## PLANNING COMMISSION MEETING AGENDA

FEBRUARY 4, 2025

### Chestnut Flats

- To allow a decrease in the minimum floor ceiling height from 12 feet to 9 feet
- To allow a decrease in the minimum building occupancy from 70% to 61%

Site Plan

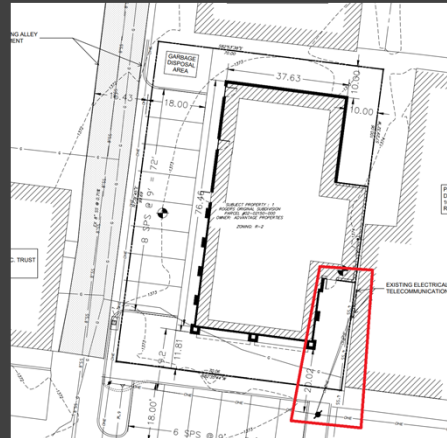
The applicant stated in their purpose and intent that they intend on moving the utilities that prevent the building from occupying the east side of the property. They are taking precaution in requesting this variance incase the utilities cannot be moved.

- The applicant intends on moving the utility lines marked in red on the site plan. At the time this staff report was written, they have not contacted the adjacent property owner so they are wanting to get this variance out of precaution.

*Site Plan*

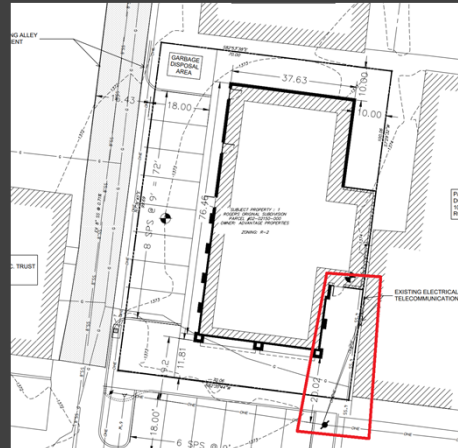
| Variance Request Factors                                                                   |                                                                                                                                                                            |
|--------------------------------------------------------------------------------------------|----------------------------------------------------------------------------------------------------------------------------------------------------------------------------|
| Is the hardship a result of any action taken by the property owner or on their behalf?     | Yes. The developer should verify if the utilities can or cannot be moved before applying for this request. The developer can still get more building in the build to zone. |
| Is the variance or waiver requested the minimum amount necessary to carry out the project? | Yes, but only if the utilities cannot be moved.                                                                                                                            |

- The applicant should contact the adjacent property owner and verify if the connections can be moved. If the adjacent property owner does not want to cooperate, then the city will be in support of this variance.

*Site Plan*

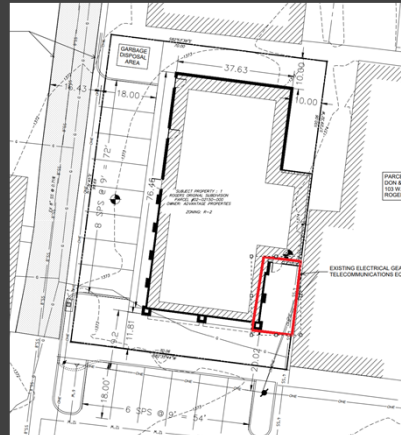
Yes, the utilities on the building to the west could be moved to allow the area marked in red to be occupied by building.

- Staff finds that it is reasonable to request the applicant contact the adjacent property owner to move the utilities.

### Development Directly South of the subject project

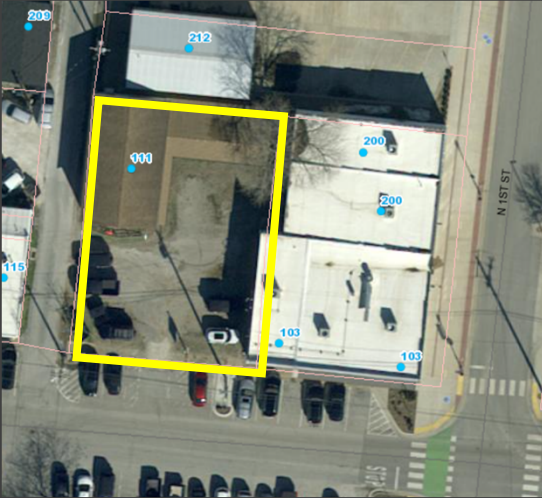
- The development directly south of this property has an approved three story residential building that is 42 feet tall. There are not overhead powerlines on Chestnut on this side of the street but there are overhead power lines in the alley.

#### ***Applicant's response from previous meeting***

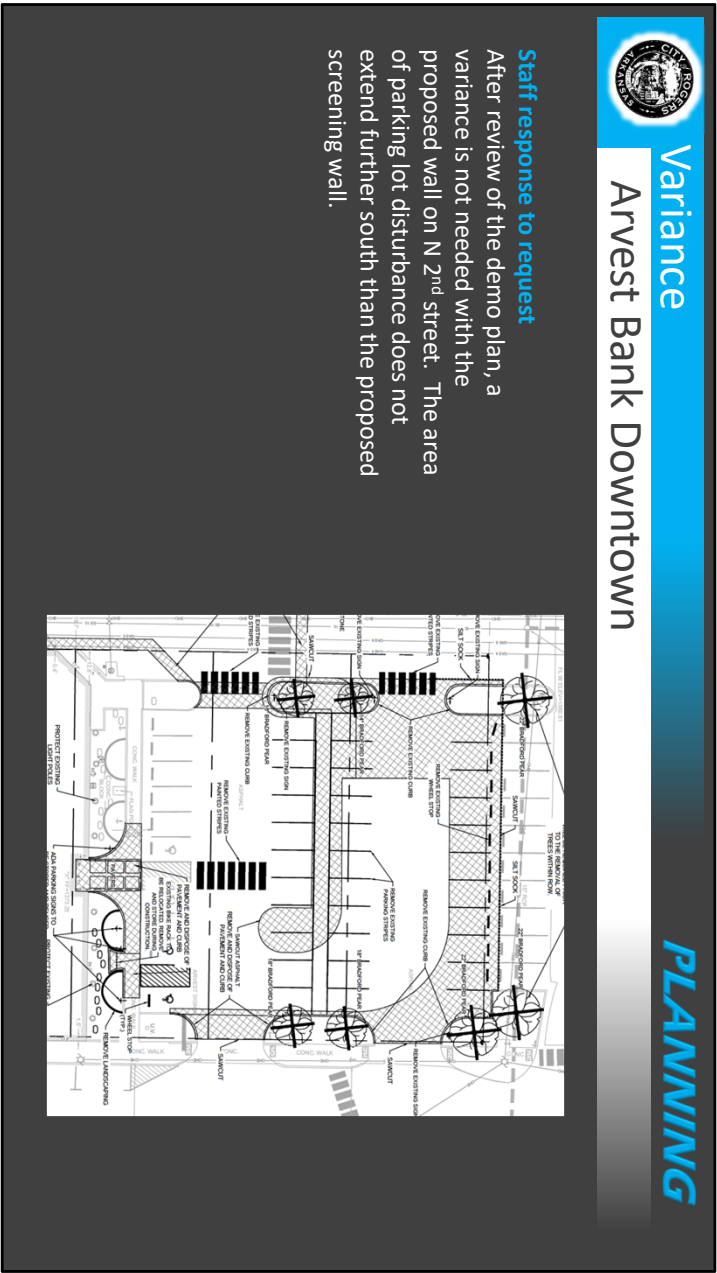
After the BOA meeting on 1/7/2025, the plans now show a 3ft masonry wall on the NE corner of the site. The wall cut short of the required on Chestnut because of the ATM area and on the south end of 2<sup>nd</sup> street because of the existing sign.

After review of the demo plan, a variance is not needed with the proposed wall on N 2<sup>nd</sup> street. The area of parking lot disturbance does not extend further south than the proposed screening wall.

After reviewing their revised plans, a variance is only needed for the Chestnut Street wall.

Site Plan

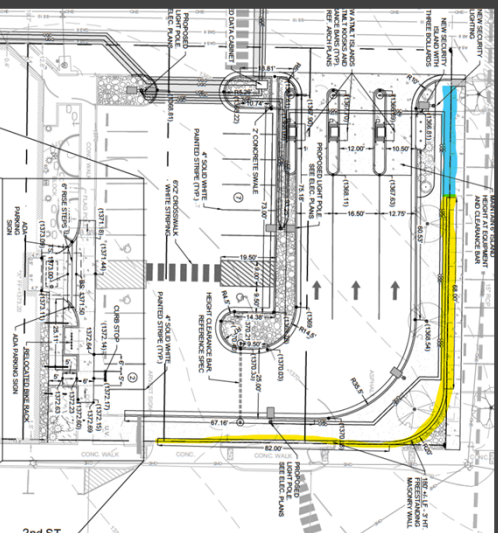
The property owner is requesting a variance to install 88feet of masonry wall. However, this isn't the minimum necessary change. The wall is the required to be 131 feet based on their area of disturbance, and installing a shorter wall doesn't meet that intent.
